Kentucky Transportation Cabinet Value Engineering Study Mountain Parkway Corridor – Construction Sequence 1

Final Value Engineering Study Report

Study Dates: May 12-16, 2014

November 14, 2014

VALUE ENGINEERING PROPOSAL SS-08

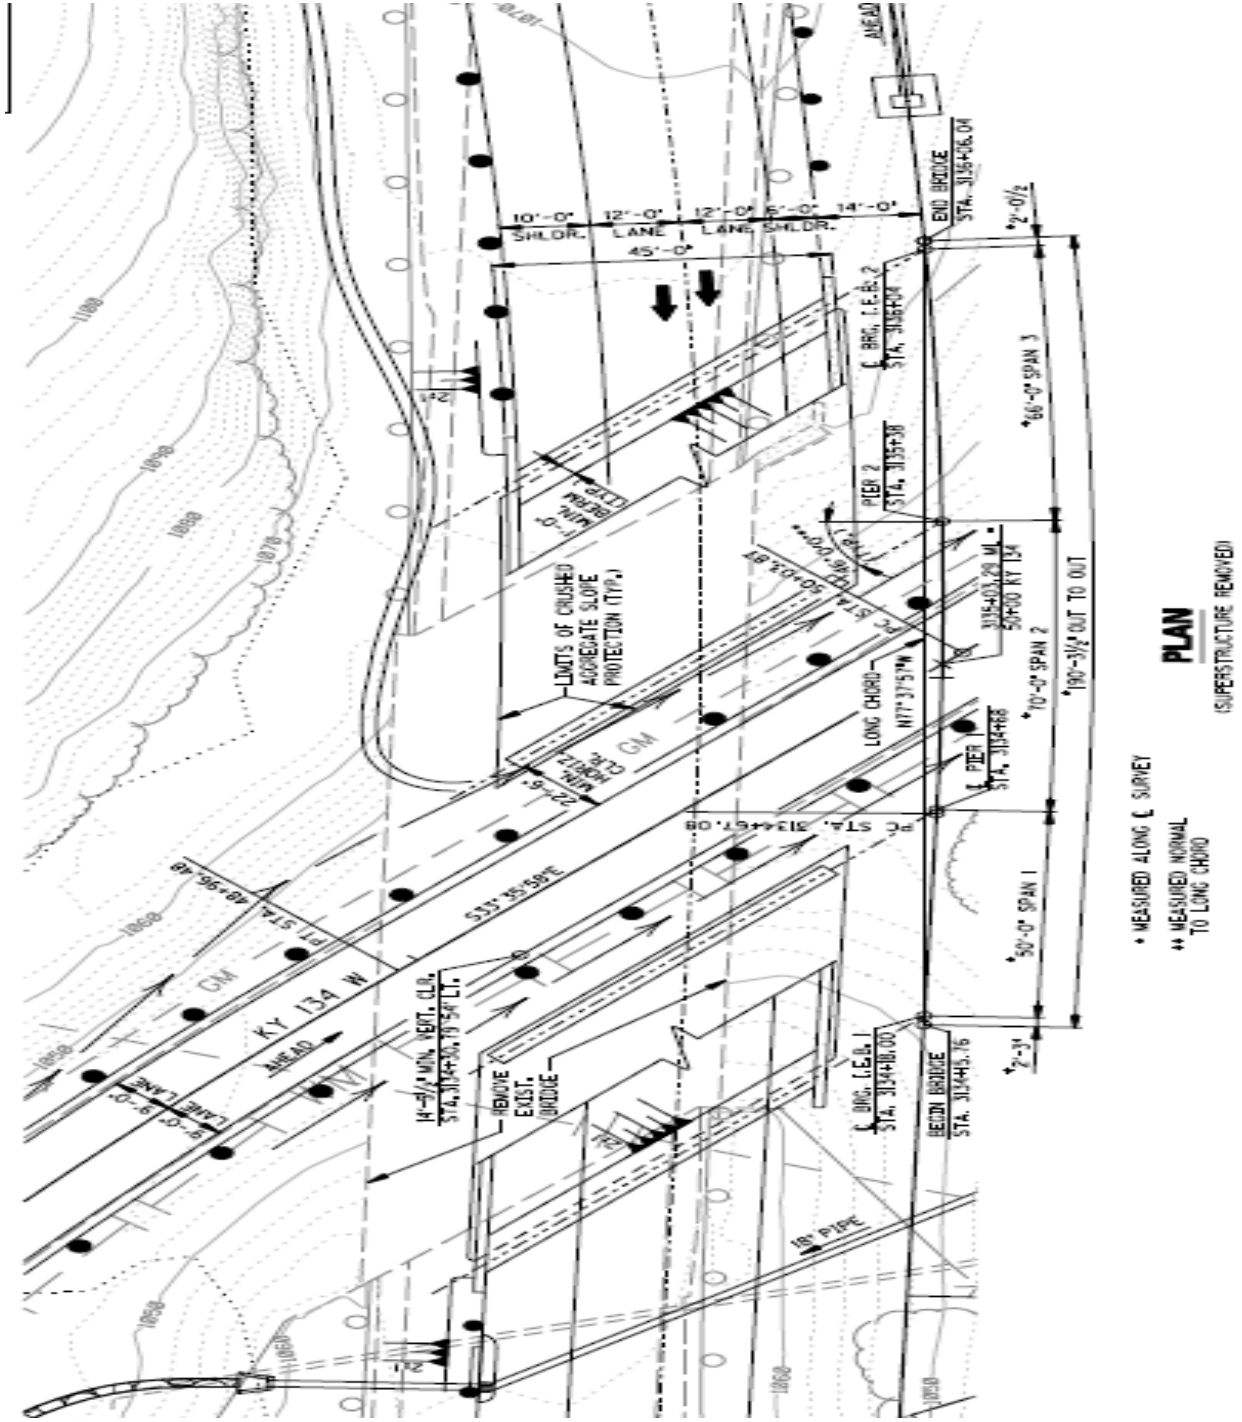
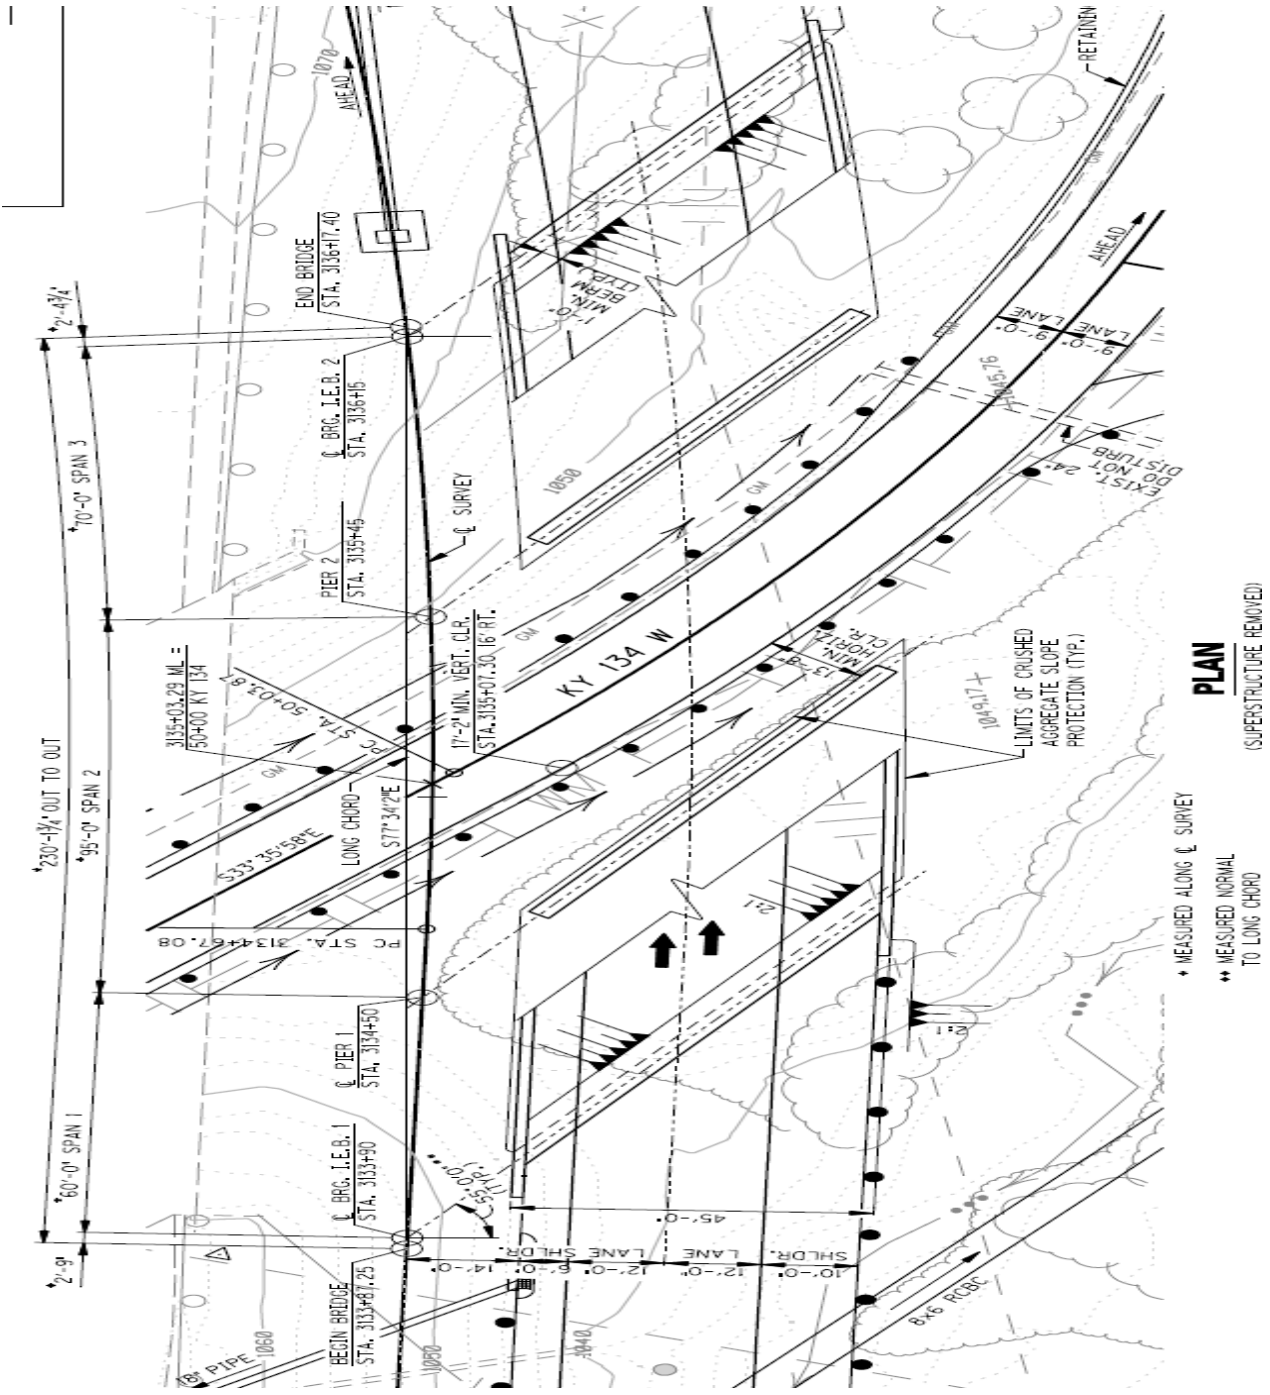
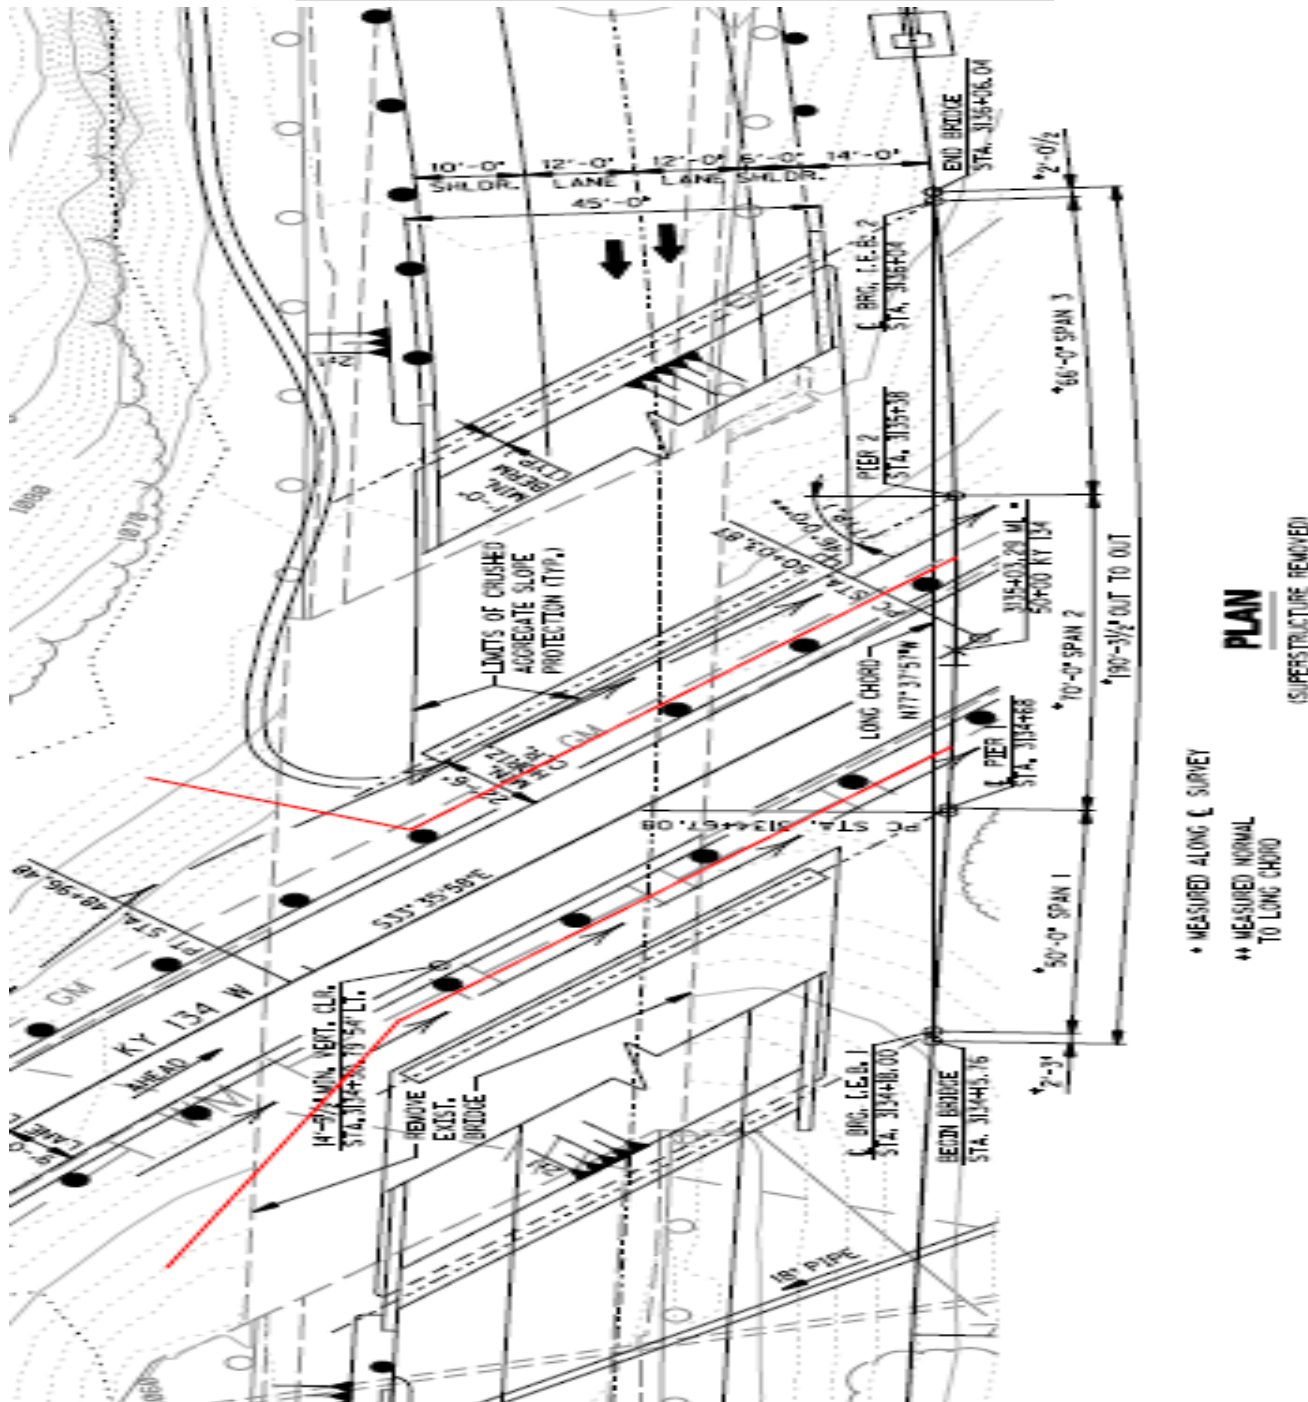
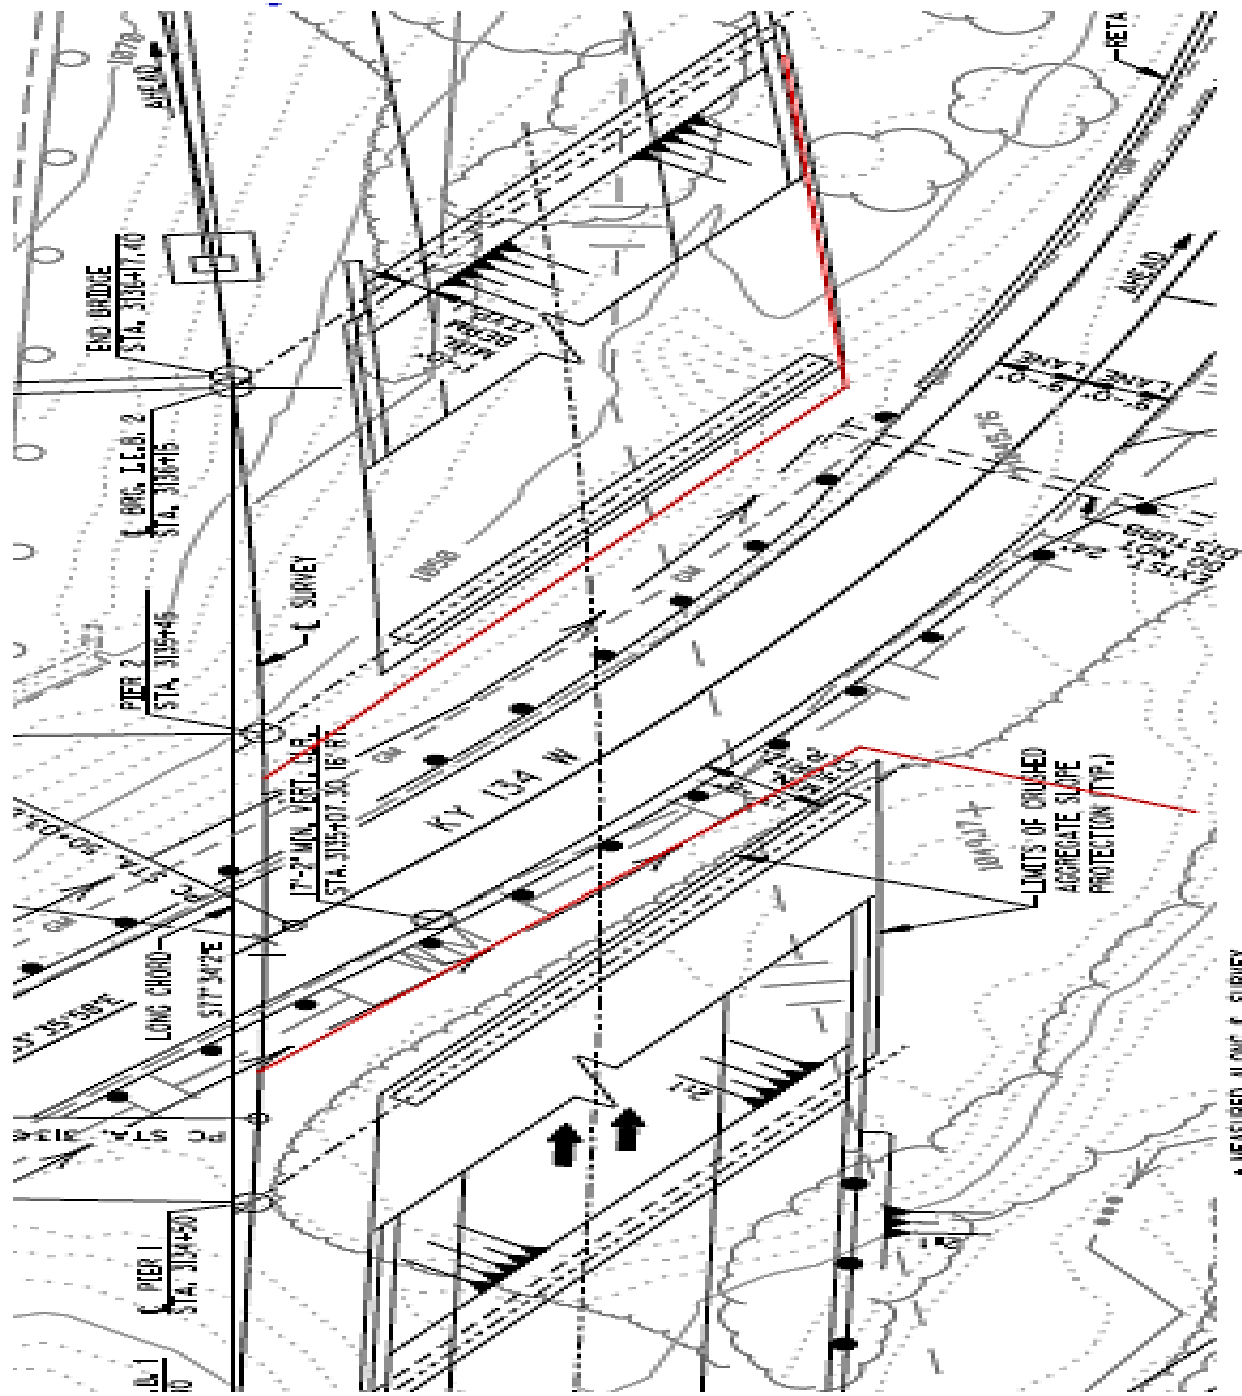
TITLE: Use single-span bridge with MSE walls at Sta. 3224+88 in lieu of three-span bridge

VALUE ENGINEERING PROPOSAL SS-12

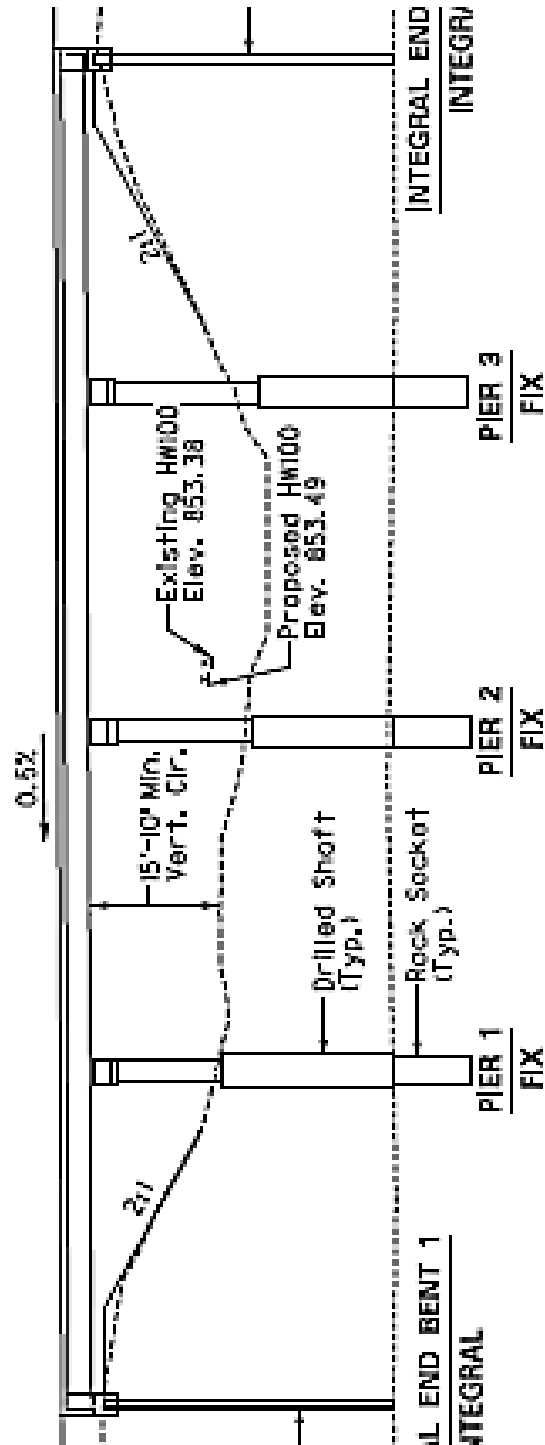
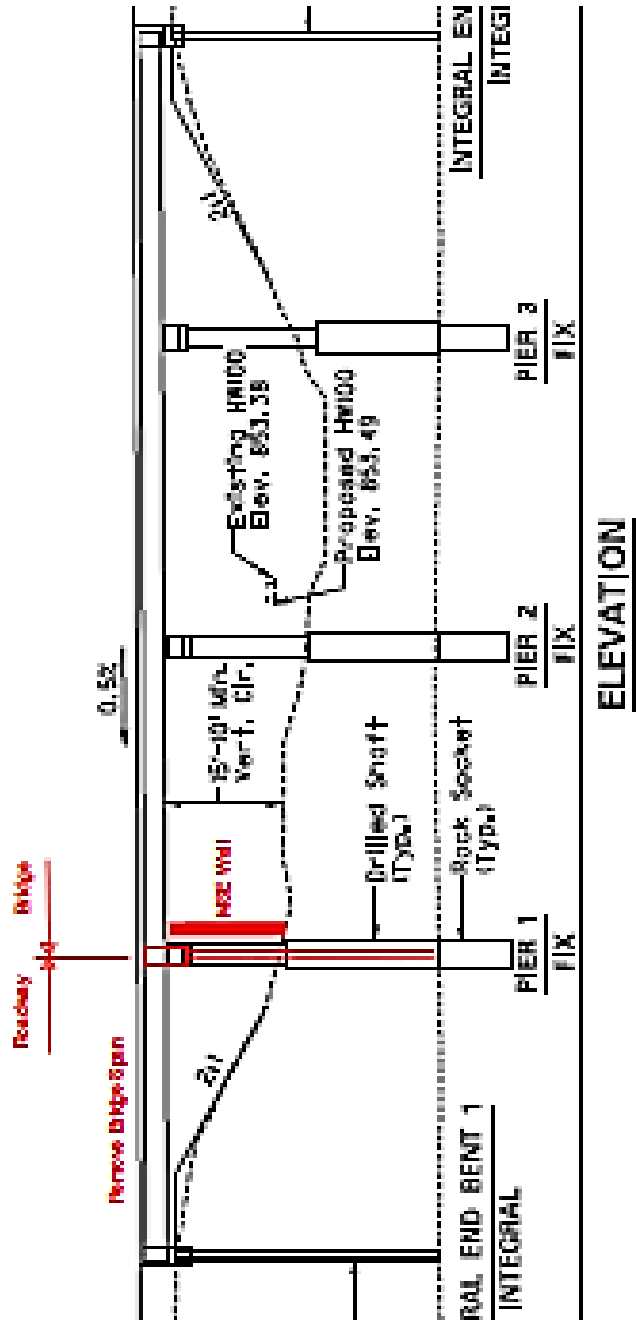
TITLE: Reduce bridge at Sta. 3350+00 from 4-span to 3-span			
FUNCTION:		Span Space	
BASELINE ASSUMPTION:			
The current bridge at this location is a four-span structure within section 10-126.50.			
PROPOSED ALTERNATIVE:			
The proposed design is to replace bridge with a three-span structure with a MSE wall.			
BENEFITS		RISKS/CHALLENGES	
• Reduce costs		• MSE wall is within 100-year storm	
• Reduce maintenance costs		•	
•		•	
•		•	
•		•	
•		•	
•		•	
•		•	
•		•	
COST SUMMARY		Initial Costs	O&M Costs
BASELINE ASSUMPTION:		\$ 451,260	\$ -
PROPOSED ALTERNATIVE:		\$ 166,500	\$ -
TOTAL (Baseline less Proposed)		\$ 284,760	\$ -

VALUE ENGINEERING PROPOSAL SS-13
Kentucky Transportation Cabinet
Mountain Parkway Corridor - Construction Sequence 1
Items #10-126.70, 10-126.60, 10-126.50, 10-126.40, 10-167.00,
Wolfe, Morgan and Magoffin Counties

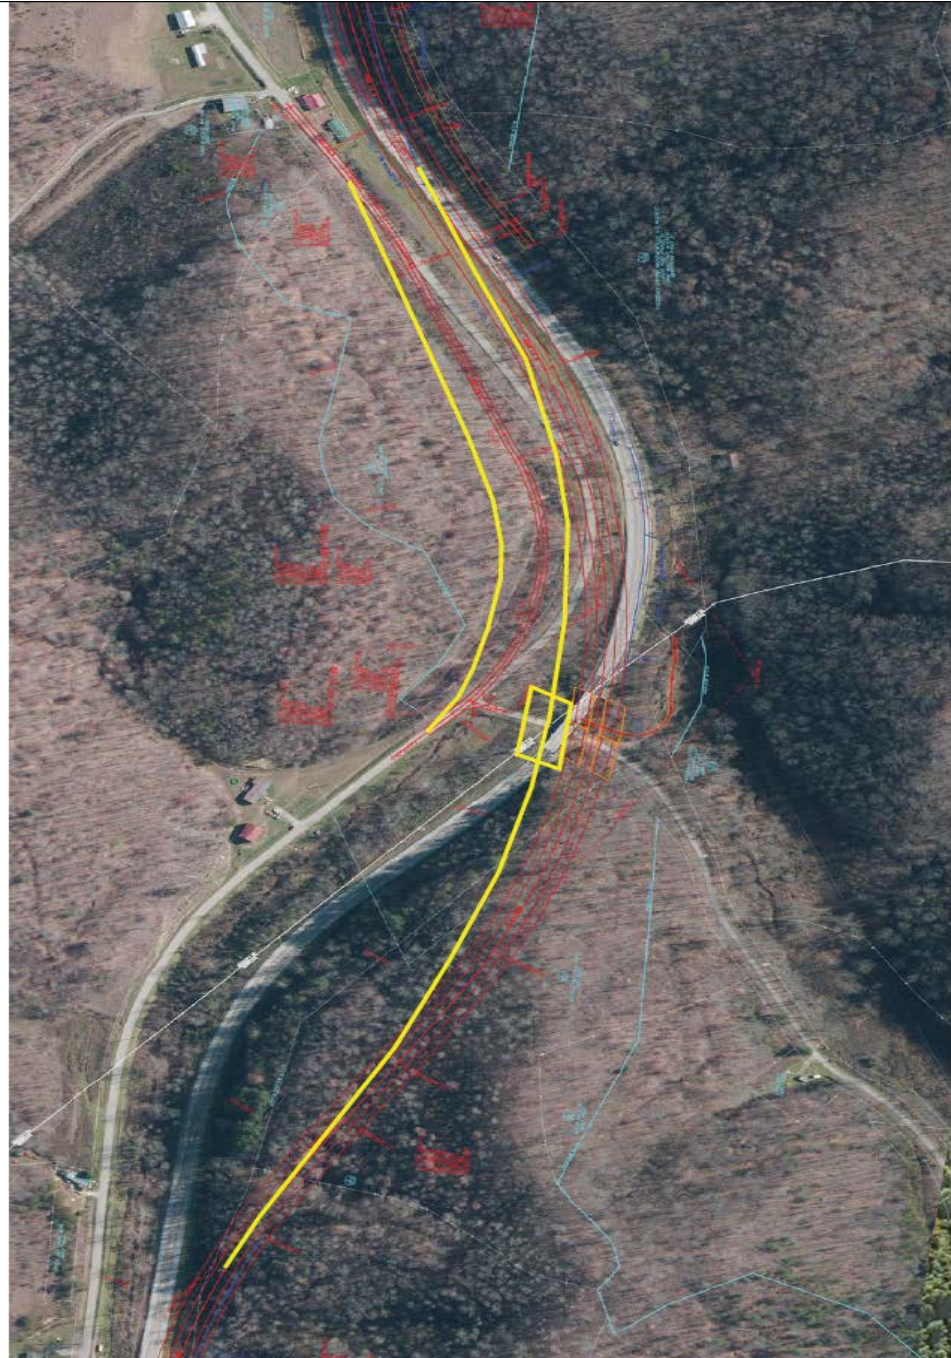
TITLE: Shift the alignment south to eliminate five twin bridges			
FUNCTION: Span Space			
BASELINE ASSUMPTION:			
The current alignment follows the FONSI document. The current alignment traverses the existing Mountain Parkway, crossing the Johnson Creek numerous times requiring six twin structures. The proposed interchange also requires four bridges.			
PROPOSED ALTERNATIVE:			
Shift the proposed Mountain Parkway alignment south of the existing plans.			
BENEFITS		RISKS/CHALLENGES

The current plans for this section will require six twin bridges to cross the Johnson Creek. The current alignment traverses the existing corridor and traverses cross country to tie back into existing. It is apparent from the current drawings, a great effort was made to be within the FONSI footprint and utilize as much of the existing pavement as possible. It may be beneficial to evaluate other alternates and deviate from the existing corridor shown on the plans. By shifting the alignment south of the existing alignment (see sketch), it is possible to eliminate five of the twin structures and reduce three of the bridges associated with the current interchange. By shifting the alignment south, there will be an additional cost associated with the extra pavement. Shifting the alignment south reduces the total amount of excavation that is needed for the project. In this evaluation, savings is approximated at \$6.5 million for pavement in cross country section, \$2.5 million in overlay, and \$4.4 million for the additional two-lane section.

Excavation savings along shifted Mountain Pkwy = 125,000 CY

Additional excavation along shifted KY-134 = 305,000 CY

Net Difference = Additional 180,000 CY of Excavation
